DEVIATION REQUEST (Attach diagrams, figures, and other documentation to clarify request)

A deviation from the standards of or in Section **ECM section 3.3.3 Open Channel Design Standards** of the Engineering Criteria Manual (ECM) is requested for the Sand Creek Channel Design – Channel Access Spacing.

CHANNEL ACCESS EXHIBIT
 SAND CREEK RESTORATION
 JOB NO. 25188.04
 10/19/23
 SHEET 1 OF 1

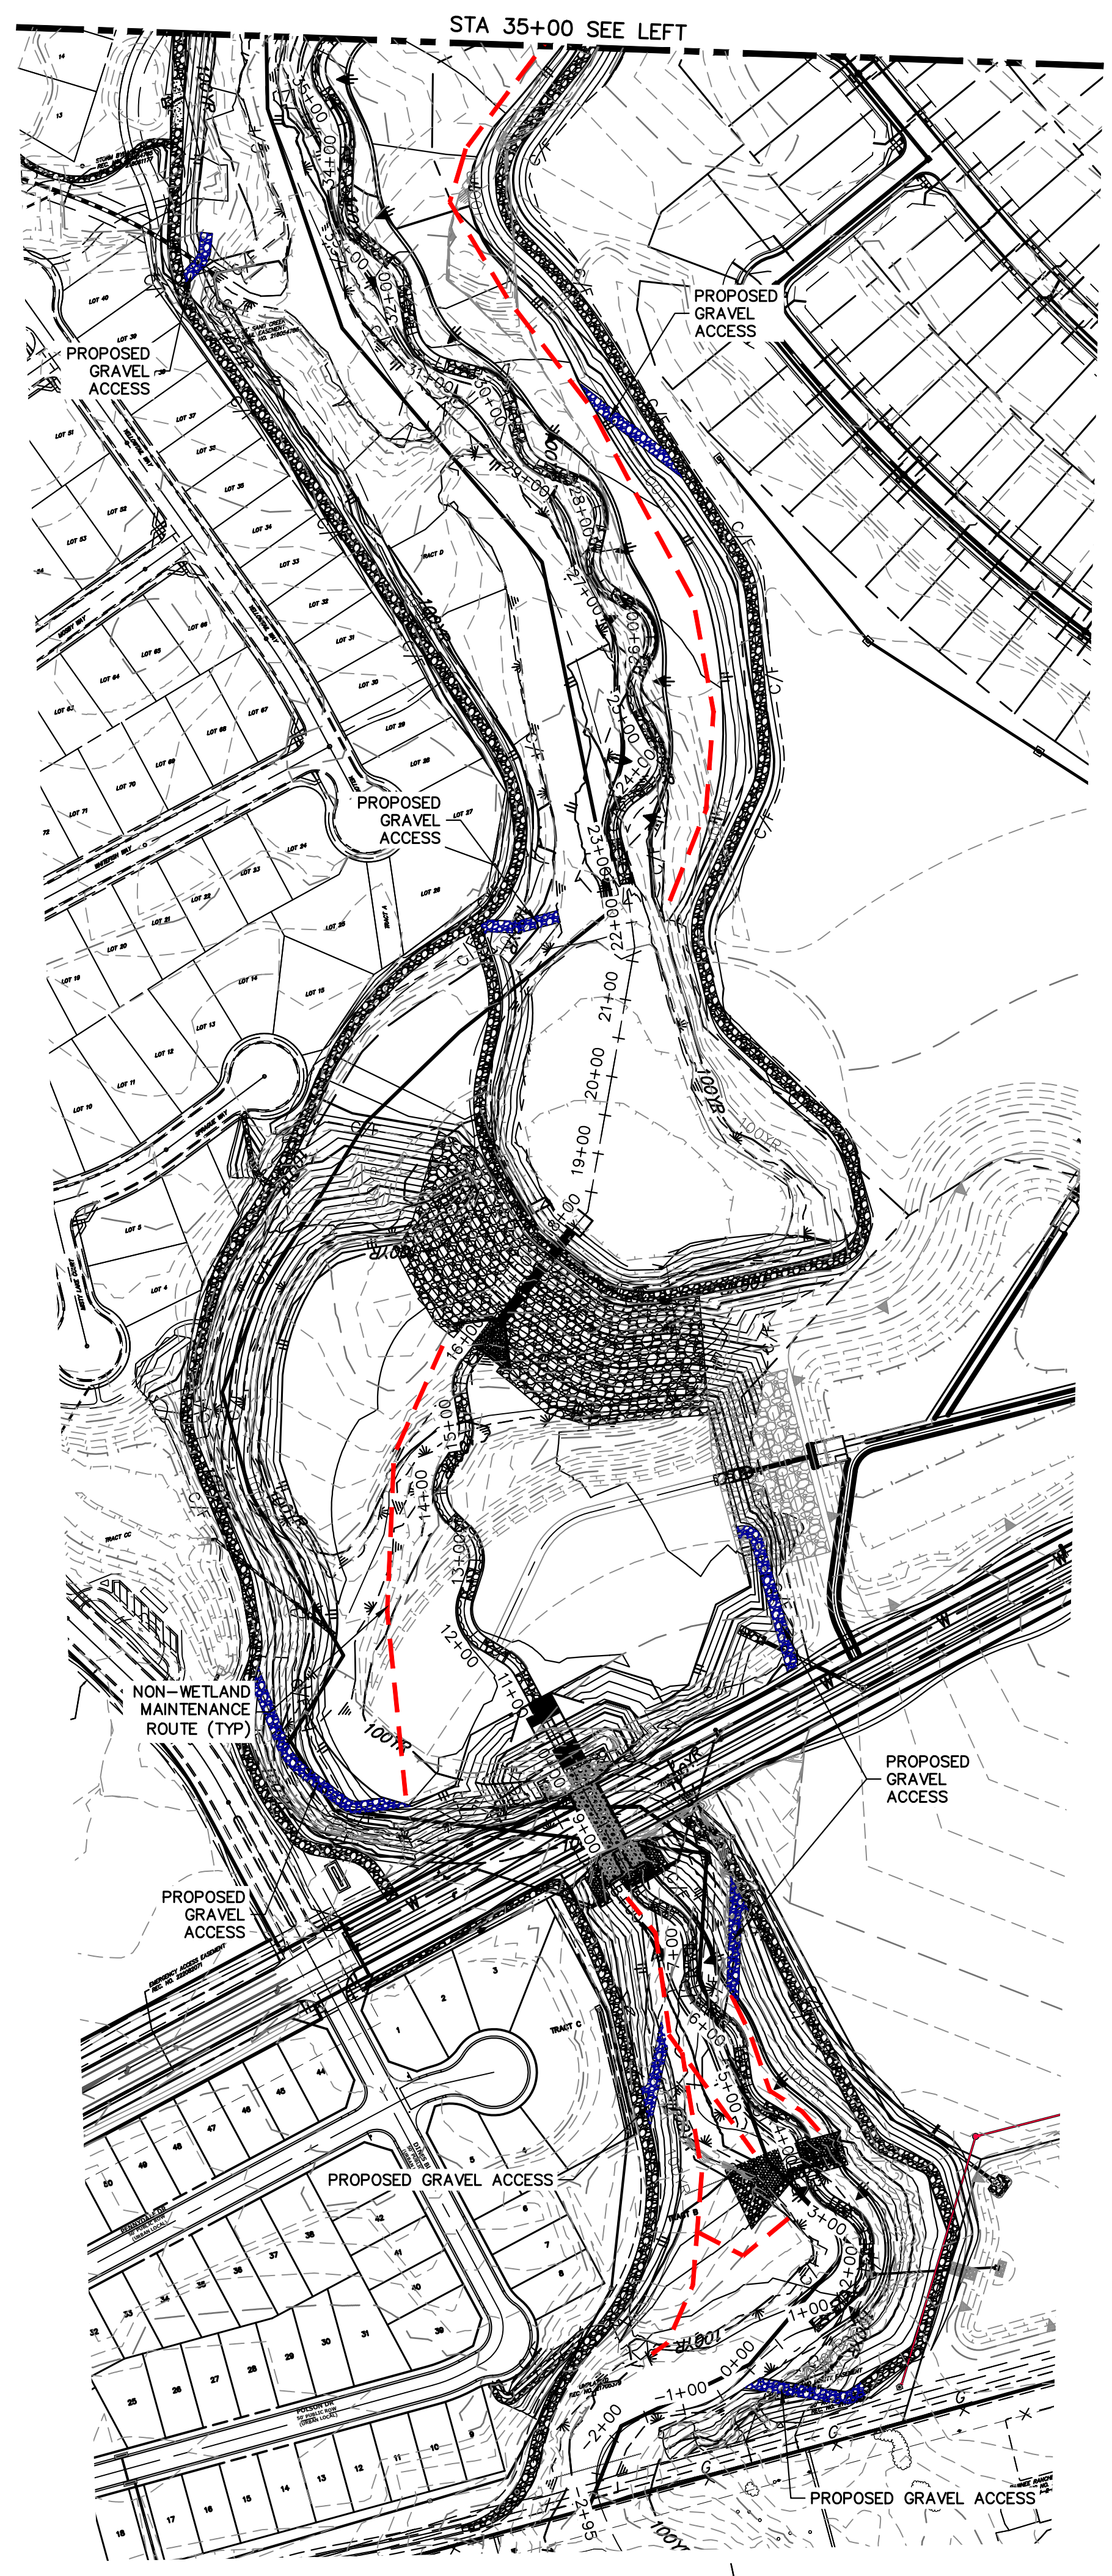
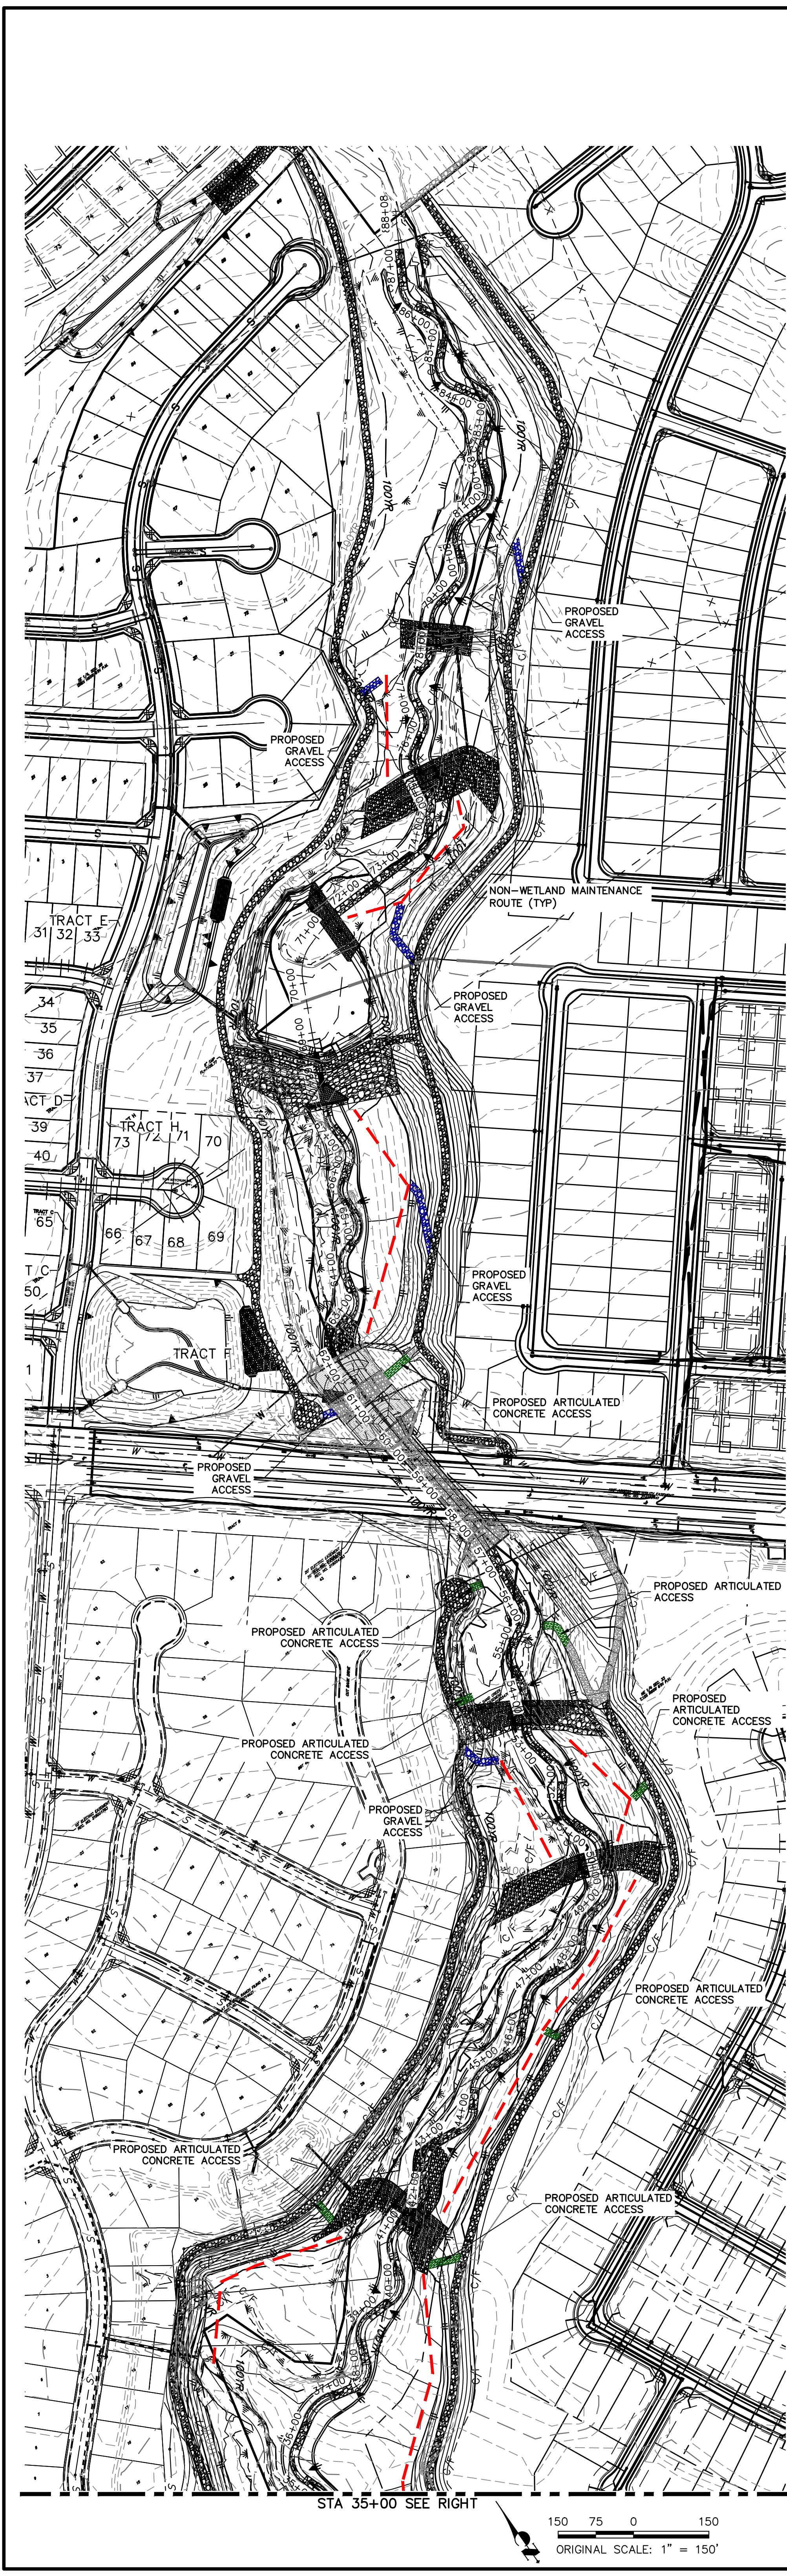
The Sand Creek Channel design has a minimum spacing of 300 feet and maximum spacing of 1,200 feet between access ramps to the bottom of the channel.

A more "natural" channel design is being proposed for this reach within Sterling Ranch and there are only 8 drop structures, two roadway crossings, one inline flood control detention pond and two existing stock ponds in the 9,000 feet of channel being improved. Access ramps to the bottom of the channel are provided near each structure listed above.

In total, there are 24 total access ramps to the bottom of the channel as shown in table in Exhibit A.

To place a channel bottom access ramp every 500 feet is not feasible as it would add to the disturbance of the existing wetland as well as reduce the area available for wetland mitigation. Because of the natural channel design concept being proposed, maintenance activities requiring larger equipment are reduced and are focused around the 8 drop structures, 2 stock ponds, inline Pond W-3 and the plate arch culverts for Briargate Parkway and Sterling Ranch Road.
